P&WC S.B. No. 28411R2

TURBOSHAFT ENGINE FUEL MANIFOLD - REPLACEMENT OF

Jan 08/2024 PW200-73-28411
Revision No. 2: Mar 05/2024 Cover Sheet

SUBJECT: Pratt & Whitney Canada Service Bulletin No. PW200-73-28411, Rev. No. 2 dated Mar 05/2024 (P&WC S.B. No. 28411R2) FUEL MANIFOLD - REPLACEMENT OF

PW206B - Parts Progression Figure 1

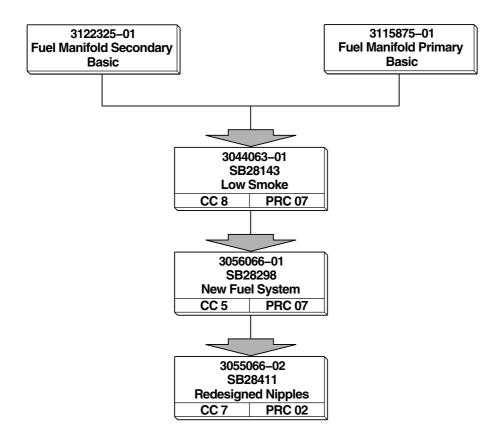
Leakage can occur between the fuel manifold and various flexible hose interfaces.

The design of various fuel manifold nipples are not optimal.

To eliminate leakage, replace the fuel manifold with one that has redesigned nipples.

Refer to Figure 1 for the PW206B parts progression.

Est. Unit List Price (\$US,	Instructions
New P/N	Keyword	Old P/N	Qty	2024)	Dispositions
3056066-02	Fuel Manifold	3056066-01	1	Quote	(A)(B)

PW206C - Parts Progression Figure 2

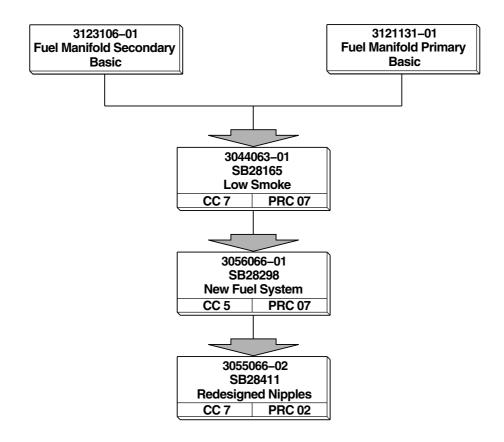
Refer to Figure 2 for the PW206C parts progression.
